City of Ramsey
Agenda
Environmental Policy Board (EPB)
Monday, June 17, 2019
6:30 pm
Council Chambers, 7550 Sunwood Drive NW

Consider Landscape Plan for Suite Living; Case of Hampton Companies

DATE	JUNE 11, 2019	PROJECT ADDRESS	TBD
PROJECT. TITLE	SUITE LIVING		
ESCROW #	117010		
DEPARTMENT:	Planning Division (Landscape Plan & Environmental Resources)		
TECHNICAL REVIEWER:	Name: Chris Anderson Phone: 763-433-9817 Email: canderson@cityoframsey.com

DATE	JUNE 12, 2019	PROJECT ADDRESS	TBD
PROJECT. TITLE	RAMSEY STORAGE CENTER		
ESCROW #	116999		
DEPARTMENT:	Planning Division (Landscape Plan & Environmental Resources)		
TECHNICAL REVIEWER:	Name: Chris Anderson Phone: 763-433-9817 Email: canderson@cityoframsey.com

TREE PRESERVATION PLAN
L1.1

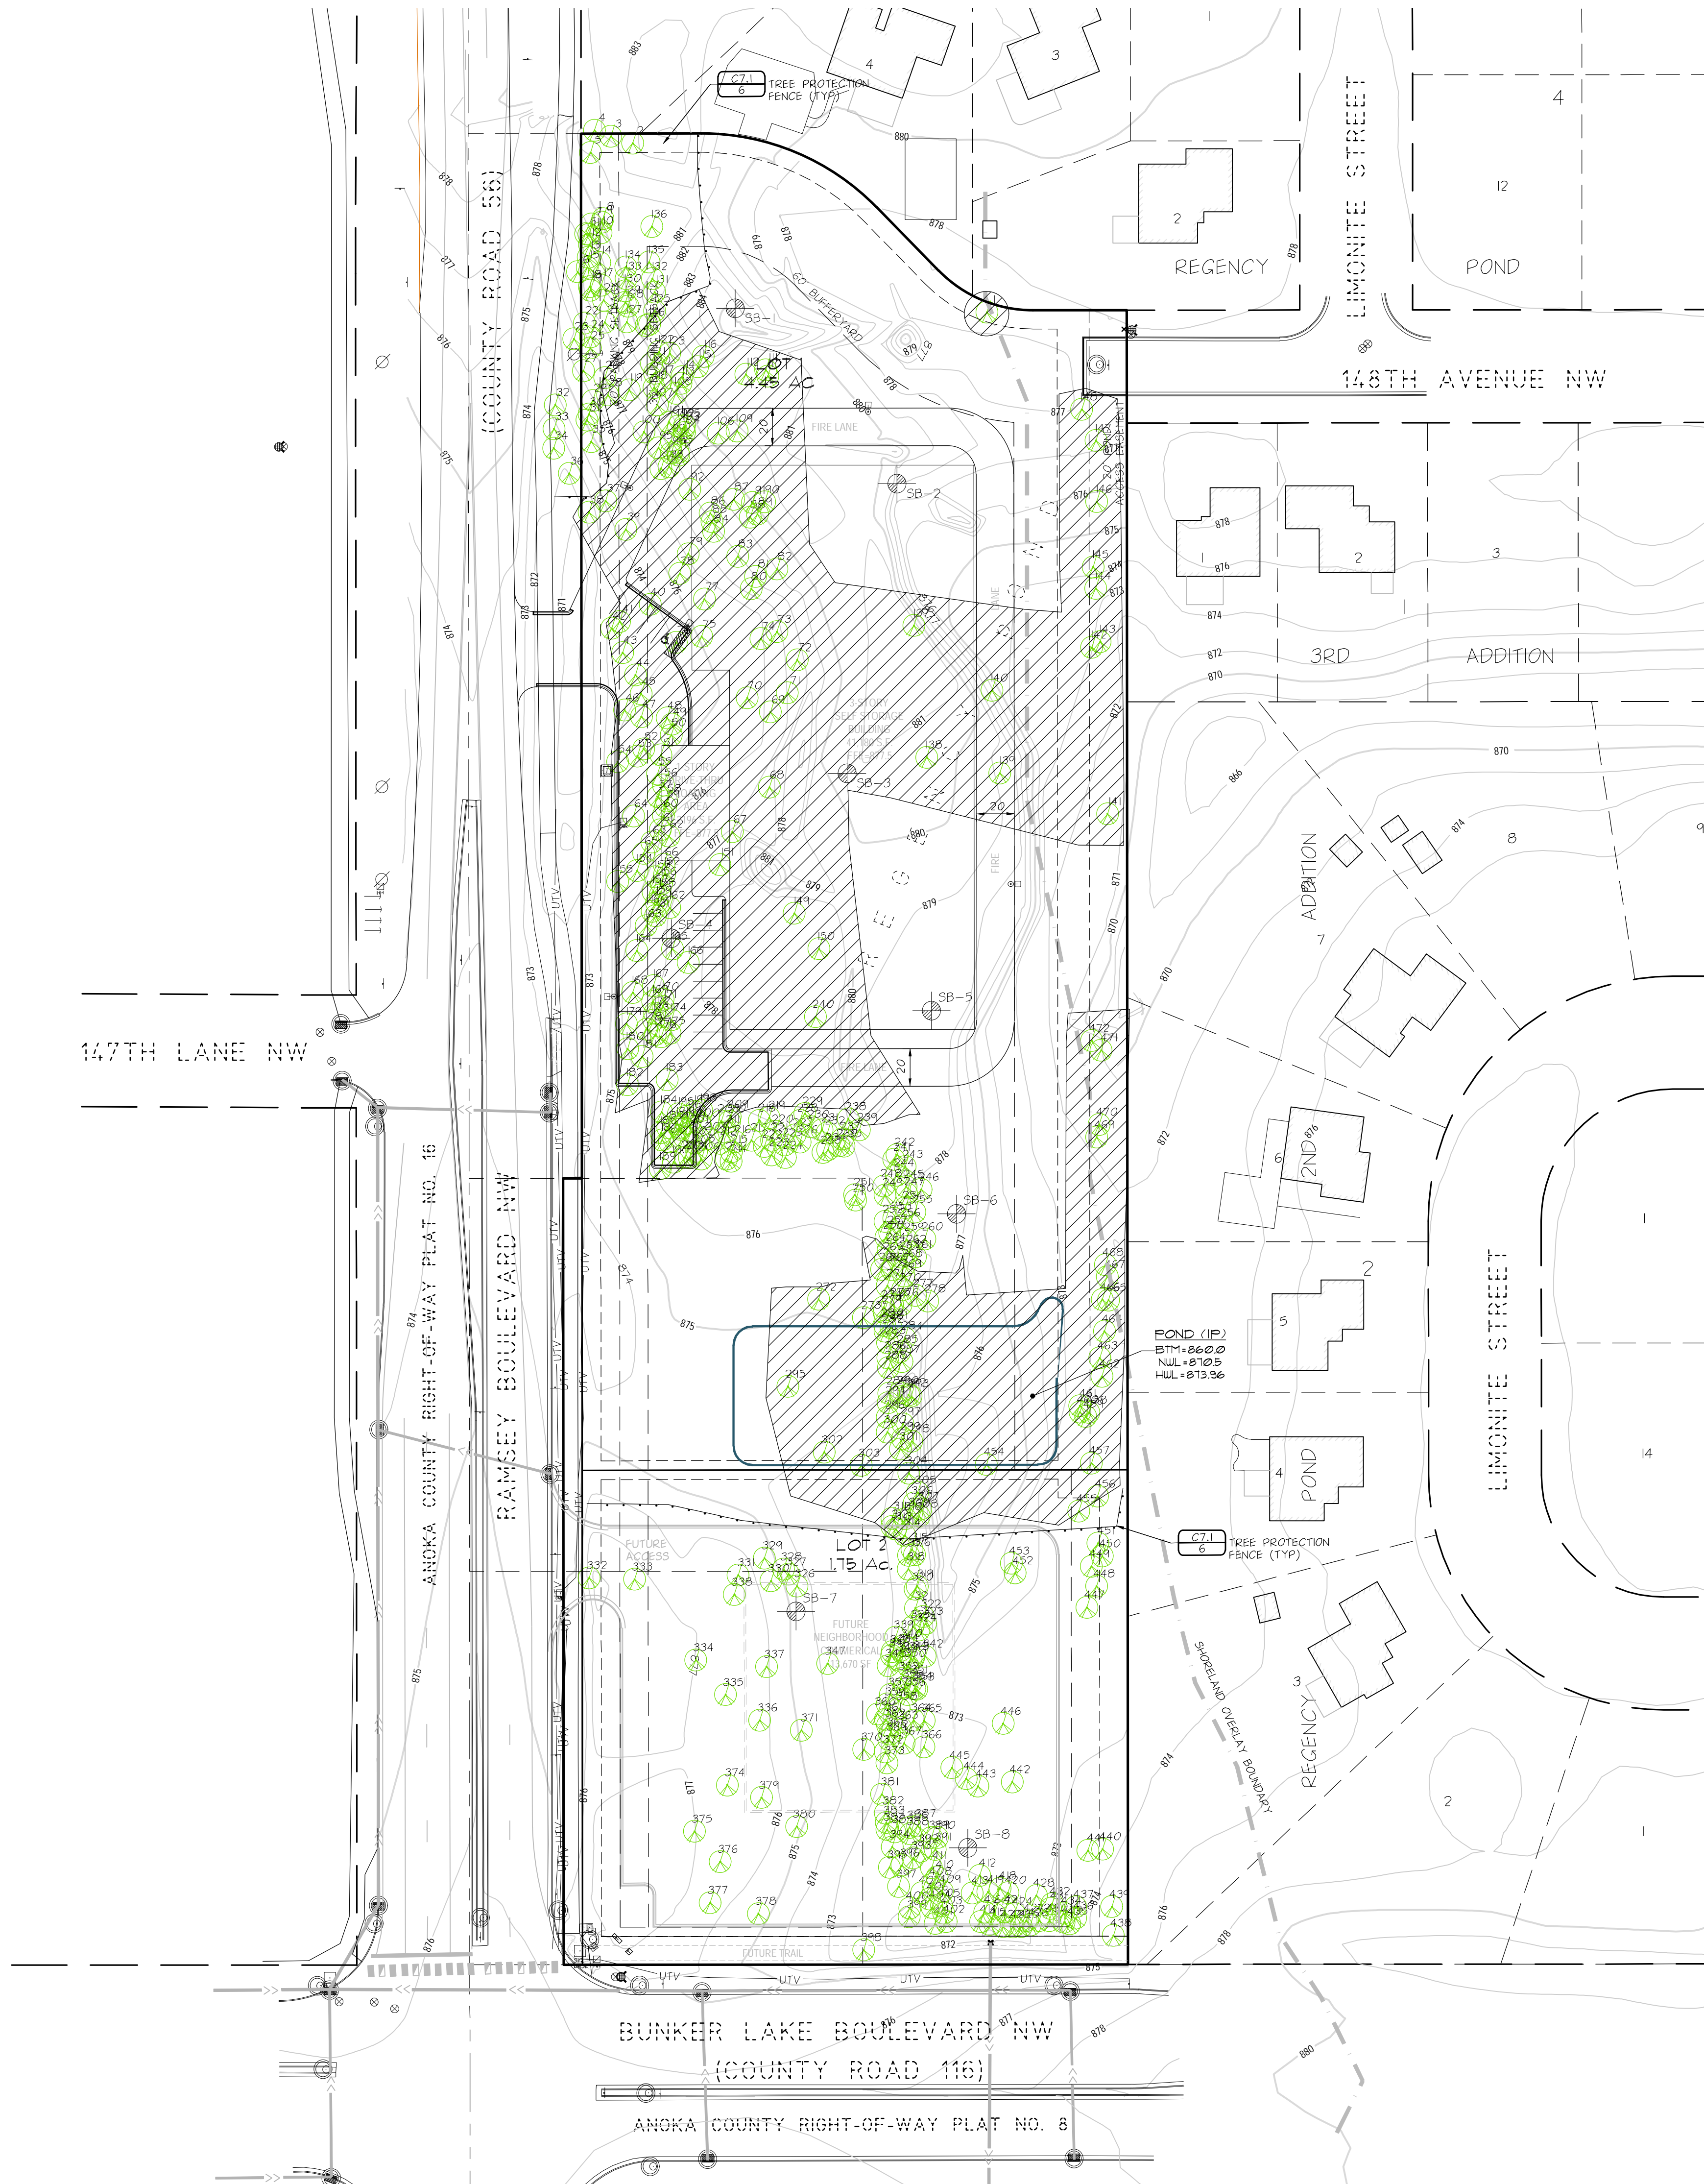
Sheet L1.1

- The note referring to Tree Protection Fence in the northwest corner of the site is not pointing to anything. Adjust accordingly. Also, add the Tree Protection Fence symbol to the legend on this plan sheet.
- It appears that a number of existing trees just south of the building and fire lane are now slated to be preserved. If so, Tree Protection Fence must be installed no closer than the dripline of these trees and it must be added to this plan sheet.

LANDSCAPE PLAN
L2.1

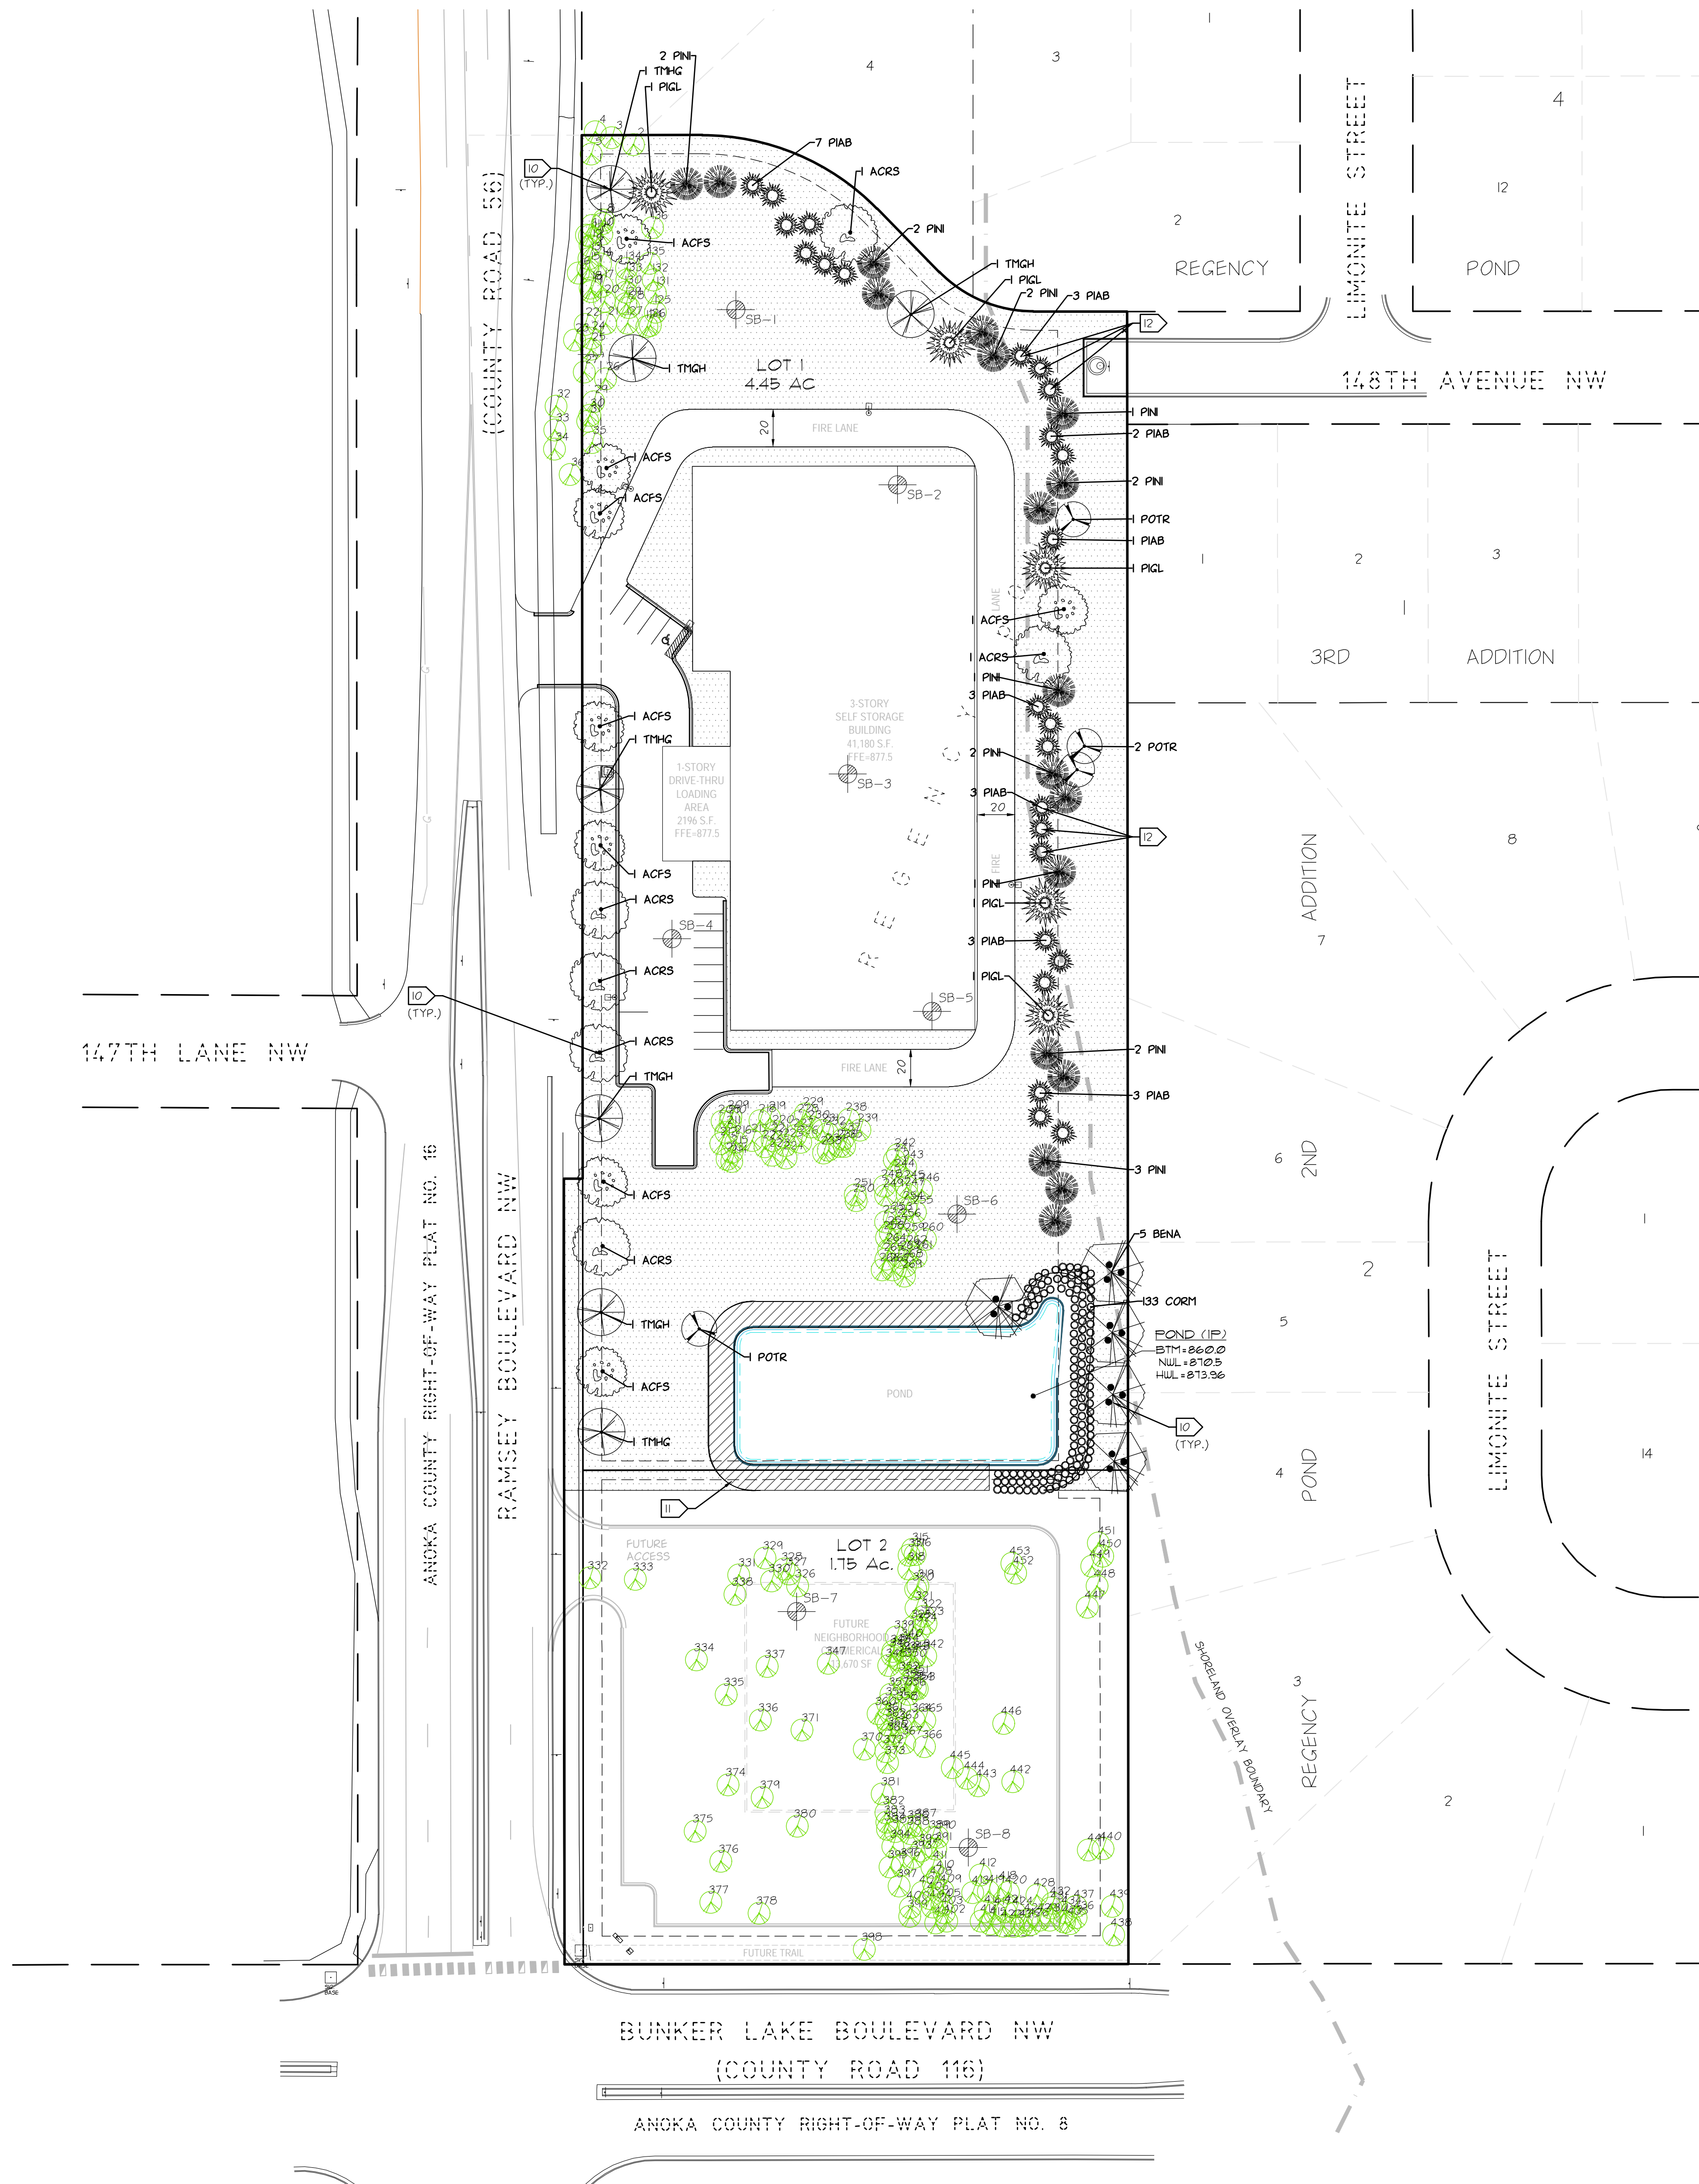
Sheet L2.1

- Landscape Note #12 states that 14'-18' Norway Spruce or White Spruce will be spaded onto the site in various locations. Staff does not object to this but that was originally proposed by the previous developer. Since the project was sold, this needs to be confirmed with the new developer. If this is still accurate, no additional revisions are necessary. If not, this note should be eliminated and the plan sheet(s) shall be updated accordingly.

- The City's topsoil requirement has been revised and no longer requires the 'Premium Topsoil' but rather simply needs to consist of topsoil with not more than 35% sand content (this is an advisory comment only).

- If an irrigation system is to be installed, notes must be added to the plan stating that the irrigation system requires a permit from the City and it must be equipped with both a rain sensor and some form of water efficient technology, such as a smart controller.

- Shrubs must be added to the bufferyard to enhance screening between existing residential uses and the proposed industrial use. This should include a mixture of larger deciduous and coniferous shrubs.
- Relocate some of the proposed shrubs around the stormwater pond to the bufferyard to assist and enhance screening between the two differing uses.
- Relocate the Harvest Gold Linden and Sienna Glen Maple from the northwest corner of the site into the bufferyard to additional screening (currently, they are interspersed amongst some existing trees being saved).
